Brunello Golf Safety Assessment

Issued

Jan 19, 2021

Hole 2

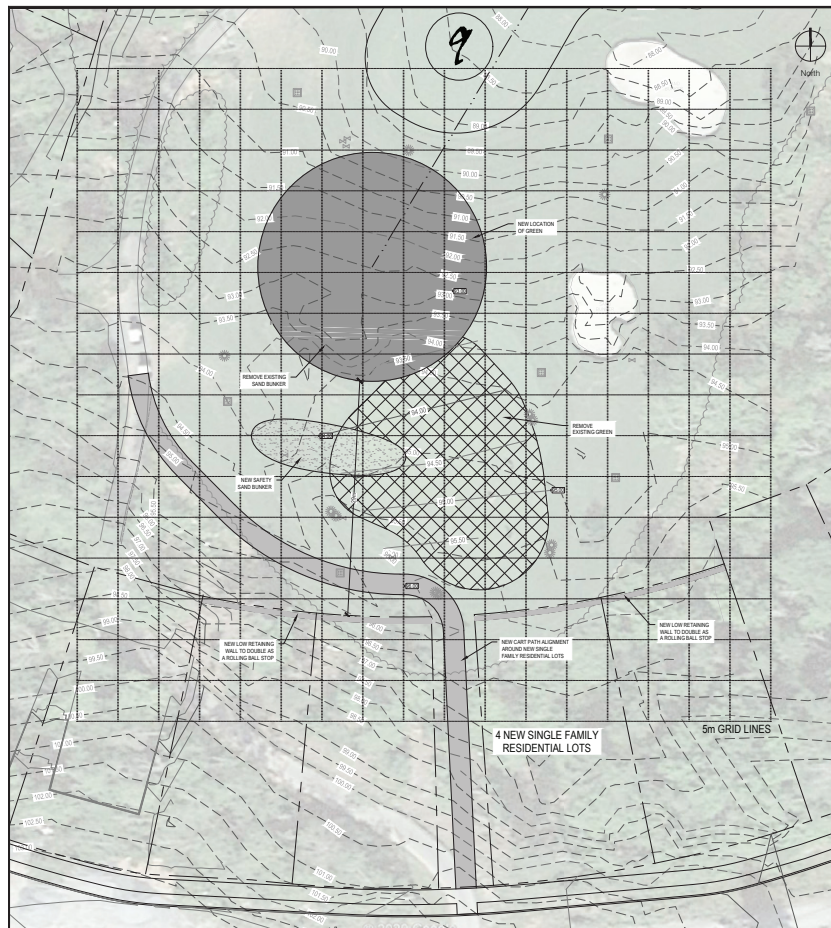
Hole 2 is proposing to add 4 new lots north of the current green site. From the back tee, the hole is an intermediate length par-3 with a length of 185 yards from the back tee, 153 yards from the main centre tee, and 100 yards from the front tee. There is an elevation drop of about 6m from the back tee to the green. Most golfers would use a 6-8 iron which provides more control than a low iron (1-5 iron). The green is currently almost 12,000 sq.ft. which is larger than a typical par-3 and could be cut back on the north side to 10,000 sq.ft. without impacting the playability of the hole. A sandtrap has recently been constructed on the right side of the green which forces most players to play to the left. The 15 degree rule from the longest tee

creates a safety radius of about 44m from the centre of the green which is close to the rear lot line of the proposed new lots. These rear lots could expect about less than 10% of all shots to enter the back yards. There are several potential remedies for this including creating an out of bounds area near the rear lot lines, adding a safety fence along the rear lot lines, reducing the green size to move the centre of the green further south, and moving the back tees closer to the northern property line to change the angle of approach. We would recommend first reducing the mowed green size on the north side of the green and eliminating the pin positions on the north of the green by about 8m. The owner could explore moving the back tee further north, and creating a new out-of-bounds area on the north side of the green. Safety fencing would be a last resort if the previous recommendations do not create the required safety outcomes but we think the chances of stray balls in these backyards would be minimal given the short distance of the Home. The back yards of the future homes, like on any new modern course, should be designed with safety in mind and the developer may want to explore enclosed decks and naturalized rear yards or conservation areas that is rarely mowed to reduce the potential for conflict. Given the above notes, new housing on hole 2 should be a manageable safety issue for the club and future homeowners.

NEW SINGLE FAMILY RESIDENTIAL LOTS

NEW CART PATH ALIGNMENT AROUND NEW SINGLE FAMILY RESIDENTIAL LOTS

REMOVE THIS PORTION OF EXISTING GREEN

NEW LIMITS OF REDUCED EXISTING GREEN

Hole 9

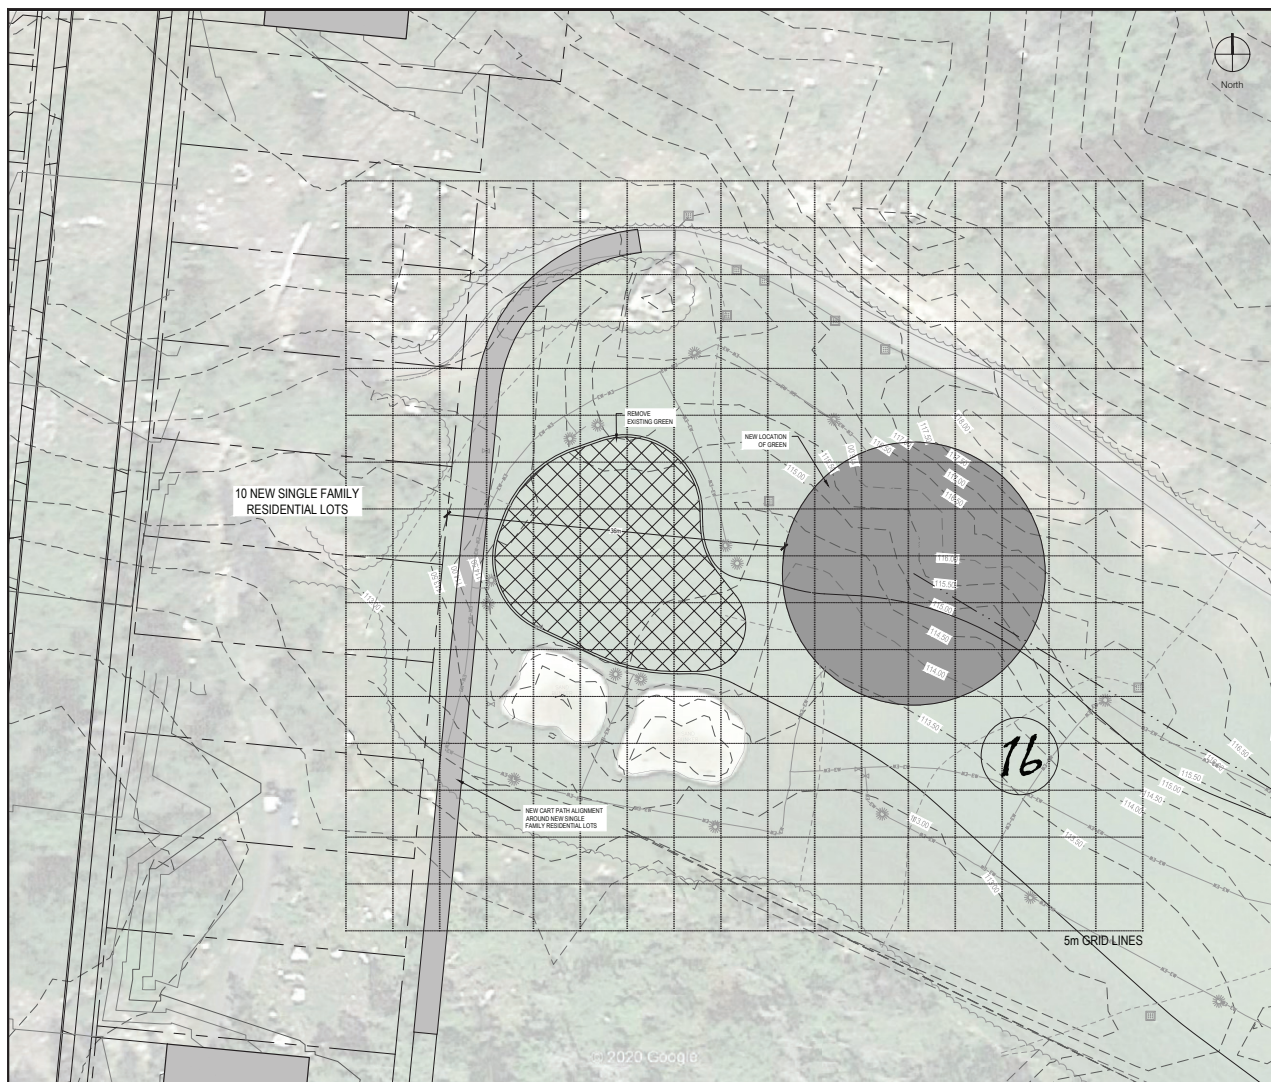
Hole #9 is a 548 yard par-5 which is considered an average to long par-5. The hole width at the 2 landing areas is generally considered very wide at 65 yards, which provides a good margin of safety for non-professionals. There are additional 10-15m 'rough' areas beyond the fairway which on each side and, taken together, these widths of play provide ample safe width along the fairway.

Long par-5 holes require larger than normal safety areas around the greens because golfers are approaching the green from a range of very different distances. After the first landing area, the hole rises about 10m from 85m to 95m, making the hole play even longer than it feels. The orientation of this hole to the southwest also plays into the prevailing wind during the summer and fall months, often requiring additional club to reach the green suggesting many golfers will play this hole short. The new proposed homes will be built well above the new green (the road is roughly at 101m in height and the new green will likely be at an elevation of 90m) so even with a walkout basement, we would expect the new lots to require some retaining walls near the back property line. These walls should significantly help in the safety margin for any 'skulled' balls.

Unlike hole 2, the green of hole 9 will need to be completely rebuilt and pushed to the north by about 30 yards to create the necessary safety margins for overshots. Relocating the green will have the added safety benefit of reducing the hole length by 30 yards to an average to short par-5 of about 520 yards, and reducing the vertical rise to the green from 10m to about 6-8m. A 2m min rock retaining wall at the property line would reduce rear yard errant shots and this could be supplemented by a new safety bunkering around the new green. The existing and future green layout is shown below.
